**Re: Lot 19 Block 2 SAD 228
Volcano Cliffs Subdivision Unit 2
5608 Kimberlite Dr. NW
Grading and Drainage Plan
Engineers Stamp Date 12/21/2020 (E10D091)
Pad Certification Date 12/21/2020
CO Certification Dated: 8/9/2021**

DRAINAGE AND TRANSPORTATION INFORMATION SHEET (REV 6/2018)

| DAVID SOULE NEW MEXICO REGISTERED PROFESSIONAL ENGINEER 14522 | GRADING AND DRAINAGE PLAN | DATE 12-20-20 |

| | | SHEET # C1 |

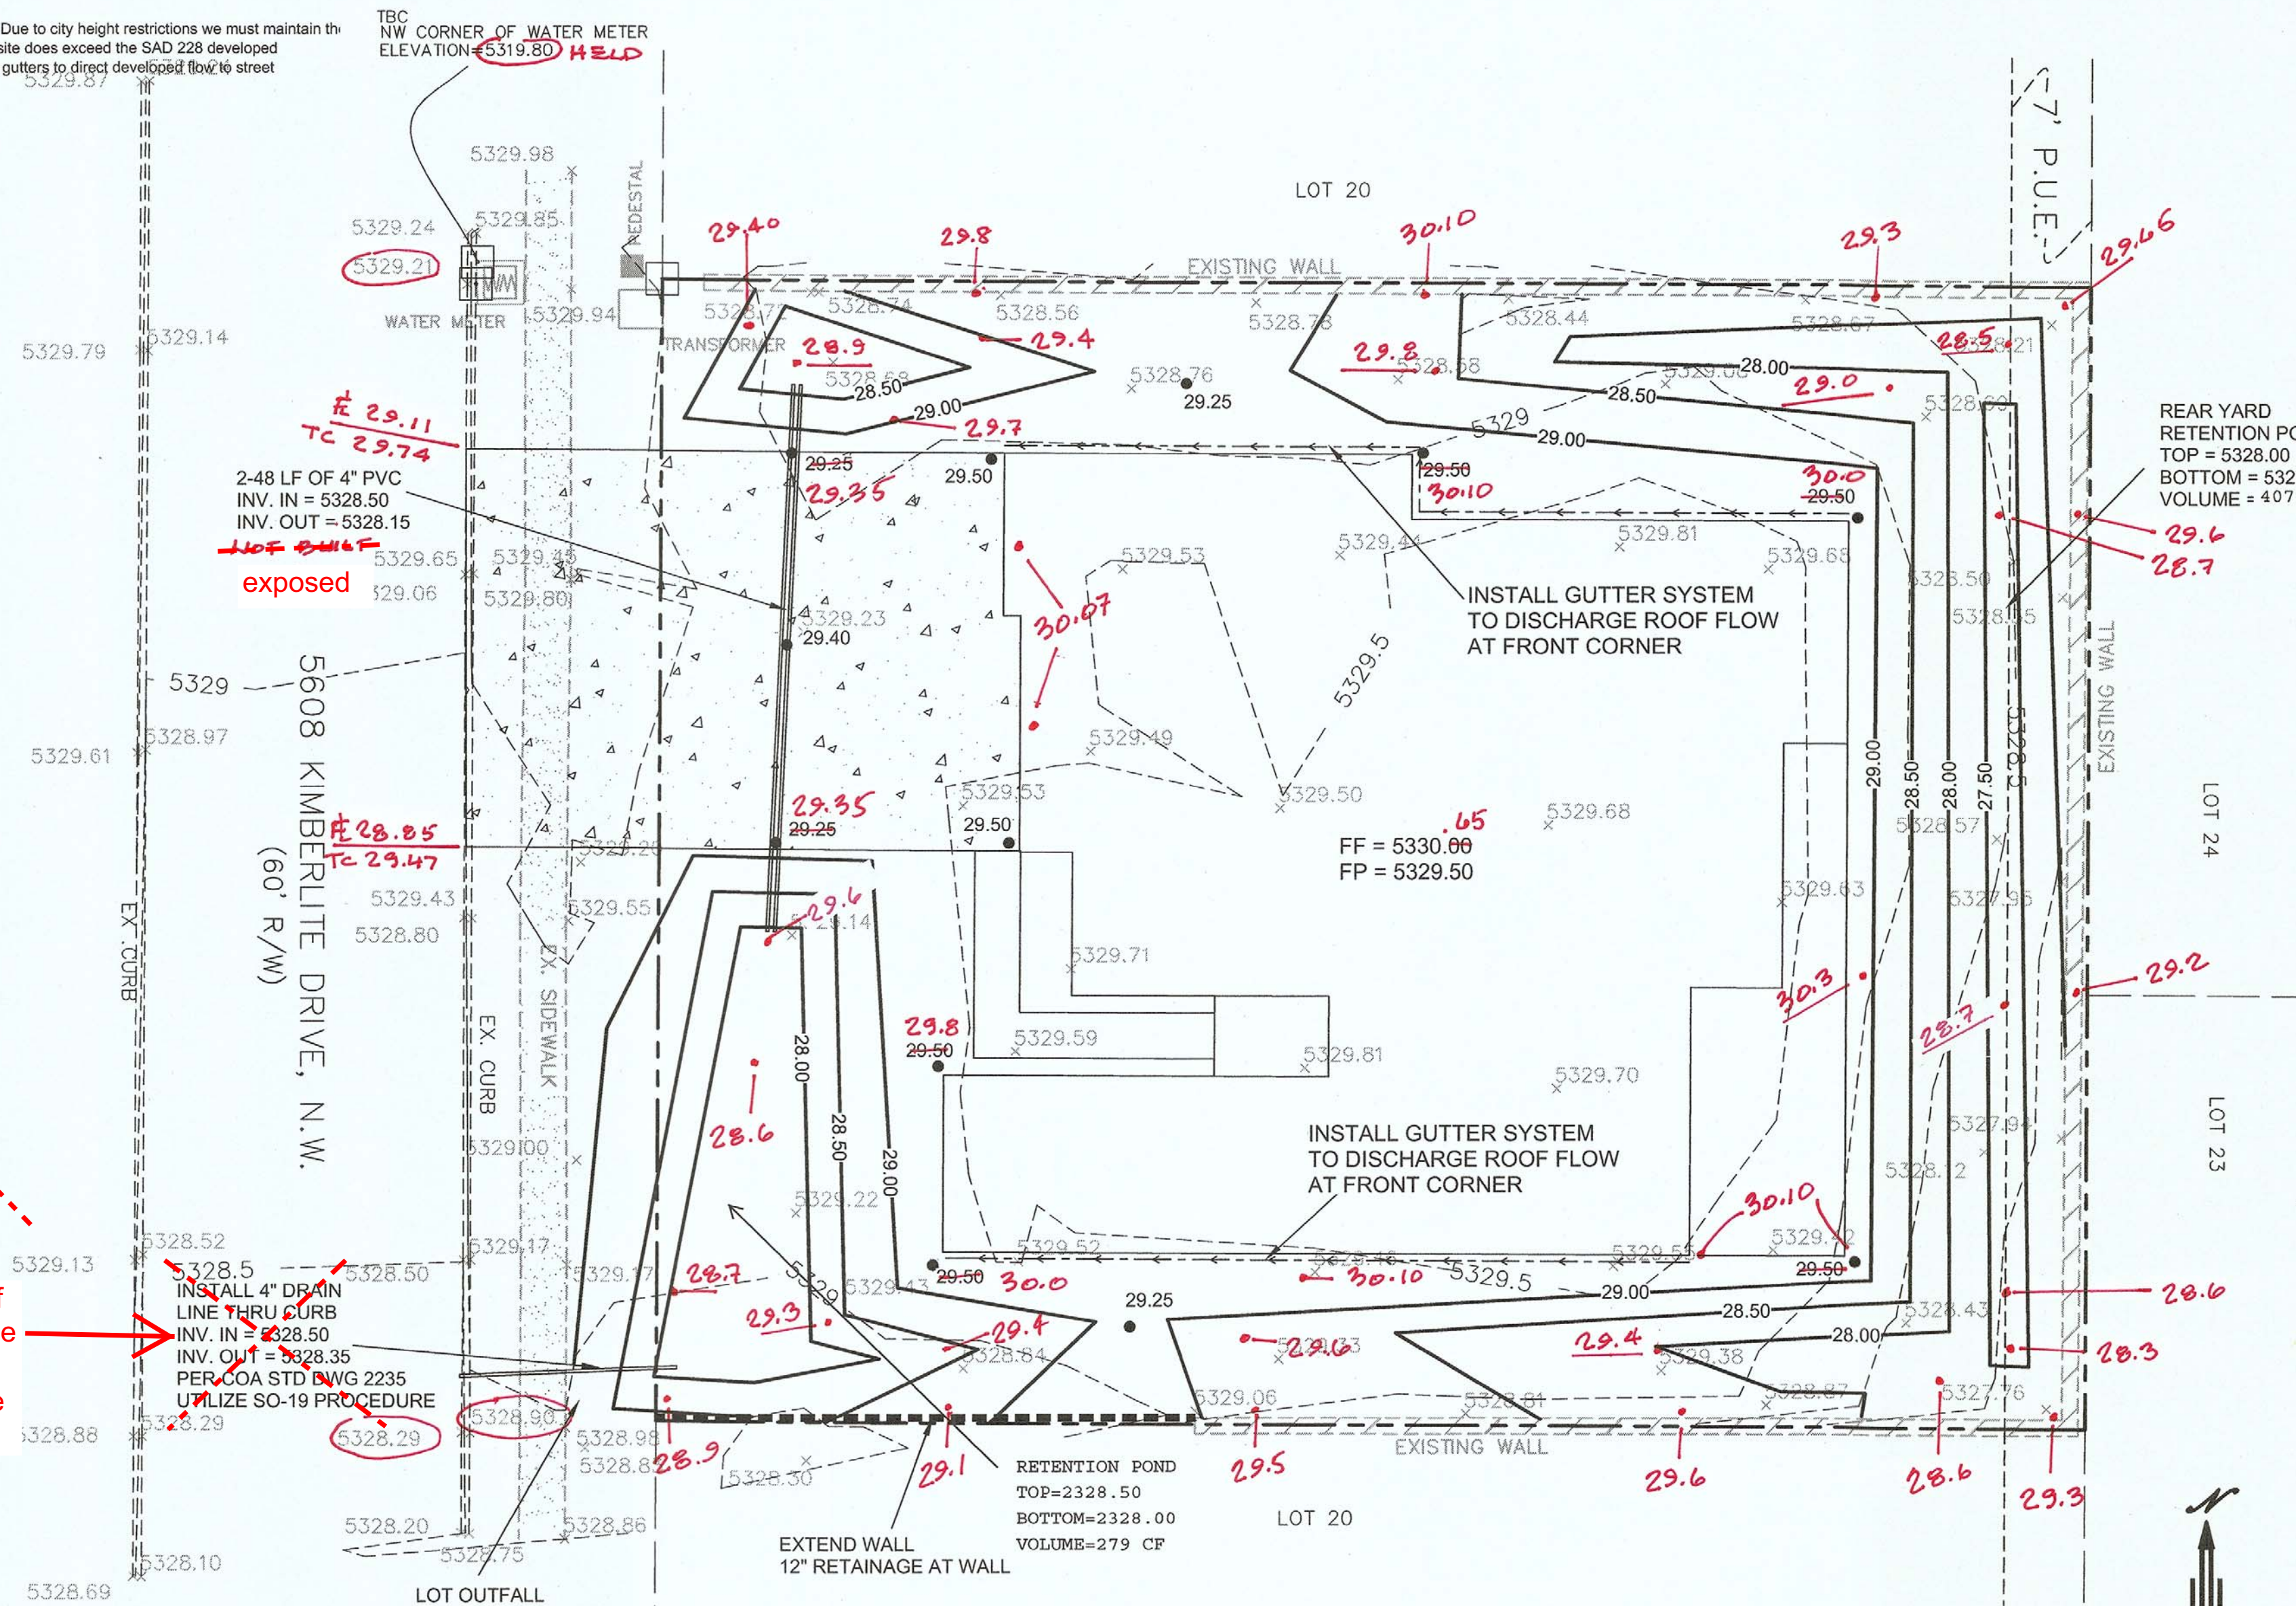
due to elevation of pad raised .65' side can drain over sidewalk, and pipe not required
